Active Errata List

CAN Microcontrollers

T89C51CC01
T89C51CC01UA
T89C51CC01CA

Errata Sheet

4. Boot Process Compatibility

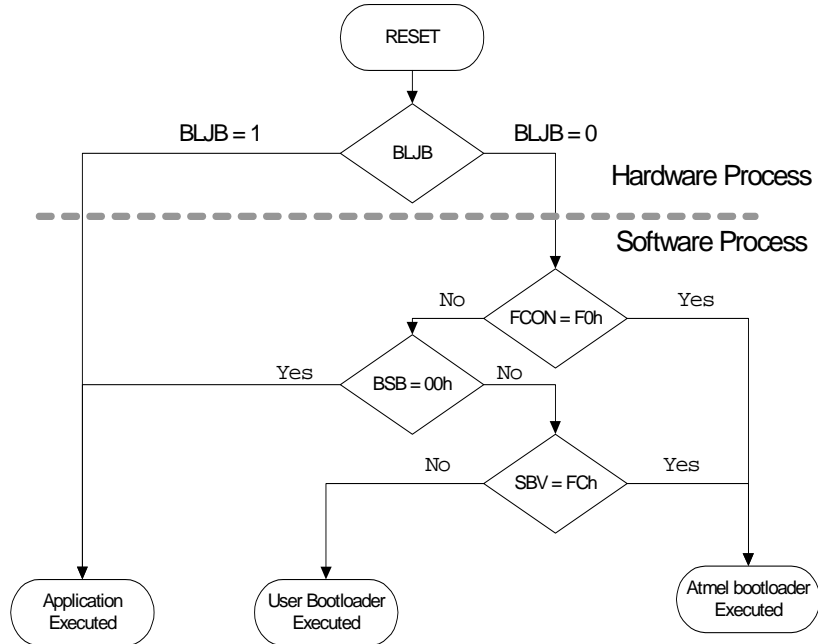
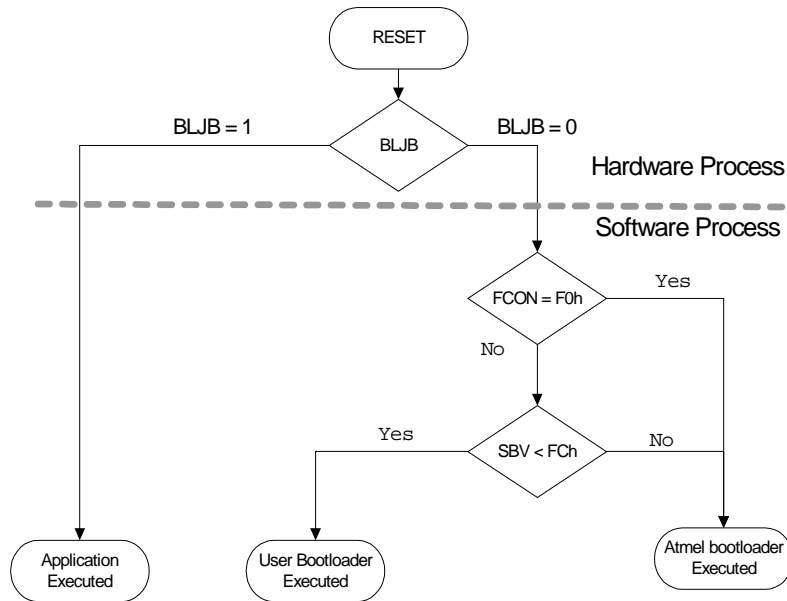
There are some differences between Boot process of bootloader 1.2 and newer versions (see below).

Version 1.2:

Version 1.4:

Use the fuse bit BLJB to start the application in both versions.
